2CAN060308

**SUBJECT:** Arkansas Nuclear One, Unit 2  
Docket No. 50-368  
Response to Request for Additional Information on the ANO-2 Relaxation  
from Performing a Bare Metal Visual Inspection from the February 11, 2003  
Reactor Pressure Vessel Head Order

**Response to NRC Request for Additional Information  
Regarding the Entergy Relaxation Request for Performing a  
Bare Metal Visual Inspection of the Reactor Vessel Head**

Figure 1  
C-Scan of Jamesport RPV head using Low Frequency ECT

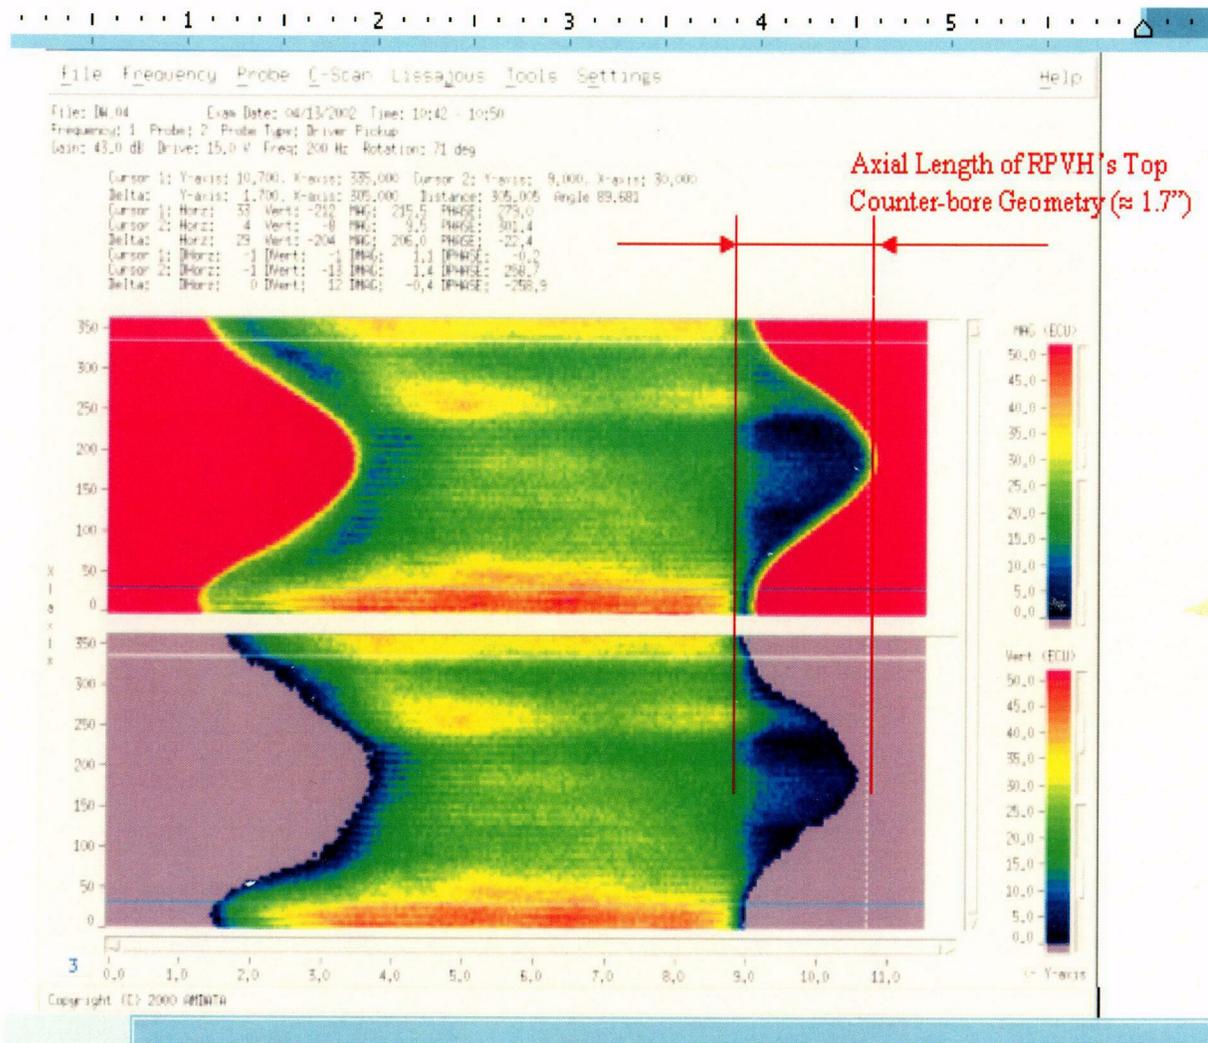
**NRC REQUEST FOR ADDITIONAL INFORMATION**

The purposes of the bare metal visual (BMV) examination required by Order Section IV.C(1)(a) are to detect the presence of deposits (indicative of leakage) at the interface of the reactor pressure vessel (RPV) head and the vessel head penetration (VHP) nozzles and to provide positive assurance of the integrity of the RPV head, i.e., that no corrosion of the RPV head is occurring. For the purpose of detecting deposits indicative of leakage, BMV is a diverse and complementary examination to the UT measurements required by Order Section IV.C(1)(b)(i) or the surface examination requirements of Order Section IV.C(1)(b)(ii). Therefore, one function of the BMV is to provide a second opportunity to identify a leaking nozzle that may have eluded detection by the non-visual examination required by Order Section IV.C(1)(b). Absent a compensatory alternative (or alternatives) that supports this diverse and complementary function of the BMV for leakage detection and the function of providing assurance of integrity of the RPV head, approval of a relaxation request to not perform the BMV is unlikely.

The licensee needs to describe how its alternative examination(s) supports the functions of the BMV, in particular the diverse and complementary function of leakage detection to the non-visual examination requirements of Order Section IV.C(1)(b), such that an acceptable level of quality and safety is achieved, or how performance of a BMV results in hardship without a compensating increase in the level of quality and safety, that justifies their alternative.

Westinghouse has demonstrated the capability of this technique to characterize changes in morphologies in the carbon steel surrounding a reactor head nozzle up to 0.250" in radial depth from the nozzle OD. Inspection results from reactor head penetrations in the cancelled Jamesport Head demonstrate this technique's ability to map the annulus geometry around an actual penetration, including a 0.015" change in radial depth created by the counter-bore near the reactor head OD. Figures 1 and 2 provide graphical results of the examinations performed as part of these demonstrations. A 0.015" change in the carbon steel RPV head counter-bore can be clearly distinguished on the graph.

When scanning across an indication that is essentially perpendicular to the scan pattern, small changes in radial depth can be detected, such as with the 0.015" counter-bore that was plotted during the demonstration process. Indications that are oriented perpendicular to the scan pattern are more easily detected than those that are parallel to the scan. During the demonstration process, an axial scan pattern was used to interrogate the test samples. The strength of the signal response received from different axially-oriented indications diminished relative to the circumferential extent, or width, of the indication. The smallest axial artifact that was demonstrated to be detectable was a 1/4" wide, 3/16" deep groove (Note: Westinghouse data shows that the minimum circumferential width measured on an actual leak path indication was approximately 3/8 inch). As the width of the artifacts increased, the signal responses were seen to increase as well. The major axis of a true indication of leakage in a reactor head penetration would be expected to be axially-oriented, with respect to the penetration tube. Entergy's inspection plan for the ANO-2 RPV head will apply a circumferential scan pattern for detection of potential carbon steel loss that would be indicative of pressure boundary leakage. If indications of potential material loss are detected, an axial scan would also be applied to further characterize the indication.
